SUBJECT: VOGTLE ELECTRIC GENERATING PLANT, UNITS 1 AND 2 – STAFF
ASSESSMENT OF RESPONSE TO 10 CFR 50.54(f) INFORMATION REQUEST
– FLOOD-CAUSING MECHANISM REEVALUATION (TAC NOS. MF1117 AND
MF1118)

Enclosure:
Staff Assessment of Flood Hazard
Reevaluation Report

VOGTLE ELECTRIC GENERATING PLANT, UNITS 1 AND 2

Figure 3.2-1. Drainage of the VEGP Units 1 and 2 powerblock area represented by a level-pool scheme (taken from the RAI response (Pierce, 2014a)).

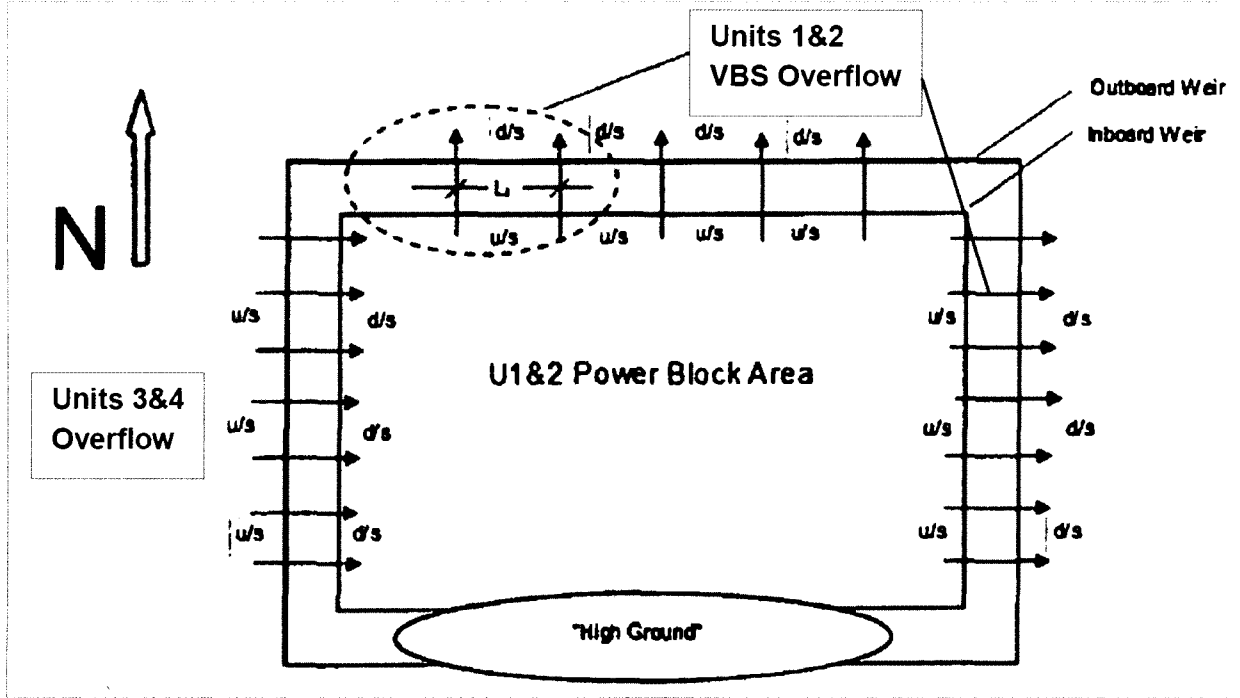
FHRR Section 2.1 discusses a HEC-HMS modeling approach to estimate the new design-basis LIP flood hazard within the area encircled by the VEGP, Units 1 and 2 VBS as shown on Figure 3.2-1. The same modeling approach was used for the reevaluation with changing PMP values. The licensee initially used a 6-hour duration PMP scenario as described in the FHRR. The licensee later submitted the result of the maximum LIP flood elevations for three additional PMP durations (e.g., 12-, 24-, and 48-hour) (Pierce, 2014b). This additional information indicates that the predicted maximum water-surface elevations and outflow rates for different PMP durations are nearly identical as they used bounding basin runoffs, but times to peak are different.

VBS is a concrete barrier encircling the VEGP, Units 1 and 2 powerblock area of approximately 66 acres (0.27 km²). Currently, VBS has a double row of barriers, and the second row of barriers was installed after the construction of Units 3 and 4 was started. The newer VBS row is mostly located outside the older VBS row. The ground elevations on the VBS area are much lower than the plant grade, so that runoff from the powerblock area would drain away. The height of the older VBS is

3.5 ft (1.1 m), and the minimum elevation of the top of VBS is approximately 218.5 ft (66.6 m). The FHRR states that the area within the perimeter of the double row VBS is modeled as a lumped-parameter reservoir. Because the plant grade is sloped from the center of the powerblock to the perimeter near the VBS, runoff will collect in the inside area of VBS. Eventually, water will overflow the top of VBS, and the VBS will act like a broad-crested weir.

As a result of the review, the staff found that the entire VEGP, Units 1 and 2 powerblock area is modeled by a single subbasin as a reservoir. An external model was used to determine a state-discharge relation within this subbasin. The licensee assumed that the subbasin is represented by a level-pool conceptual model. The level-pool model is a direct representation of the principle of the conservation of mass which states the change in storage is equal to the inflow less the outflow. One of the major input variables on the model is runoff created by a PMP scenario within the powerblock area. The licensee applied a level-pool assumption for water that flows within the subbasin and collects behind the VBS.

The staff reviewed the licensee-provided onsite topography map (Pierce, 2014a). The staff noted that the some elevations for the VEGP, Units 1 and 2 area, especially in the central powerblock area, are higher than the nominal plant grade. The area near the Reactor Buildings and Turbine Buildings, which are safety-related structures, are well above elevation 220 ft (67 m). The staff noted that this critical building area would be inundated significantly by accumulated runoffs from nearby building roofs and the LIP flood levels on this critical area would be much higher than the licensee's estimated elevation of 219.3 ft (66.8 m), which is lower than the land surface elevations. The staff found that one uniform water-surface level estimated on the top of the VBS system cannot represent the varying flood elevations at all locations within the VEGP, Units 1 and 2 area, especially at the center of the powerblock area which is where many safety-related buildings are located.
